Appendix G4

Email correspondence with Buckinghamshire Council Highways

From: Kirby, Lee
Sent: 18 October 2024 15:44
To: andrew.cooper@buckinghamshire.gov.uk
Cc: Shojaee, Sina; Gibbs, Hattie
Subject: Land North of East Claydon Substation, East Claydon Road, East Claydon - Transport and Highways - 18.10.24
Attachments: 24_02556_SO-HIGHWAYS_COMMENT-3300532.pdf

Proposed Construction Access Route

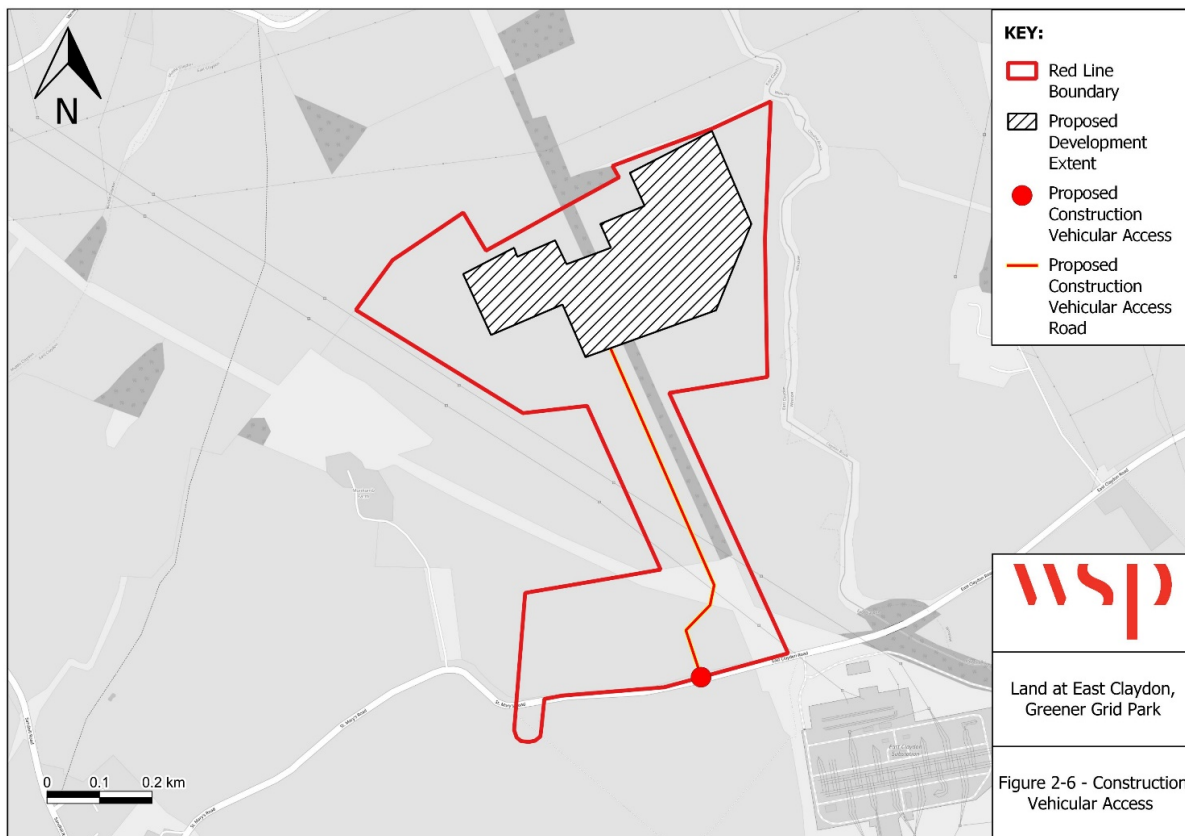
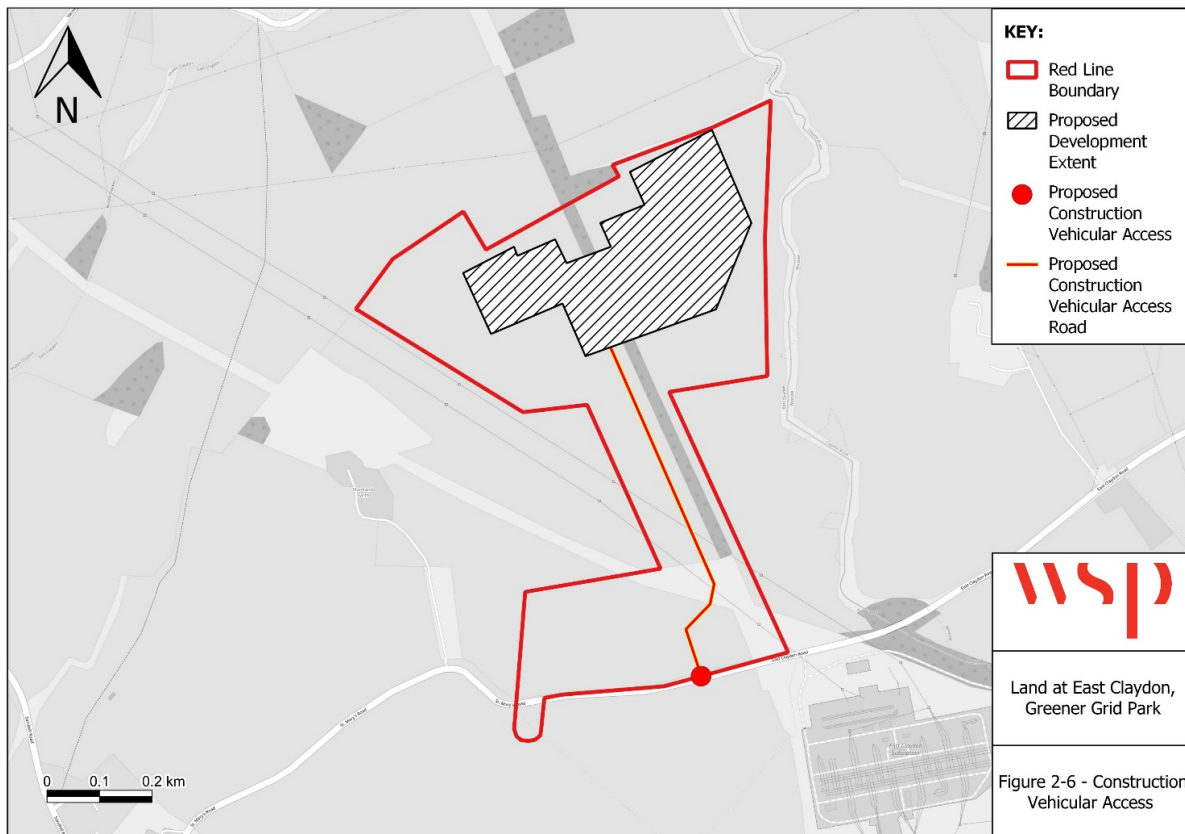
From my experience, one of the key elements is the assessment of the proposed construction vehicular access route '*broken down into sections which will look at speeds, visibility, on-street parking, public rights of way, footways, road safety and an overall assessment etc;*' **and evidence of site visits.**

The proposed construction access route from the proposed development is along East Claydon Road, Granborough Road, Vicarage Road, the A413 and the A241 (east and west) as shown in the plan below, which I note that you have no in-principle objection to as per your EIA Scoping Opinion response. As you have stated this is the most direct route to and from the site and utilities classified roads.
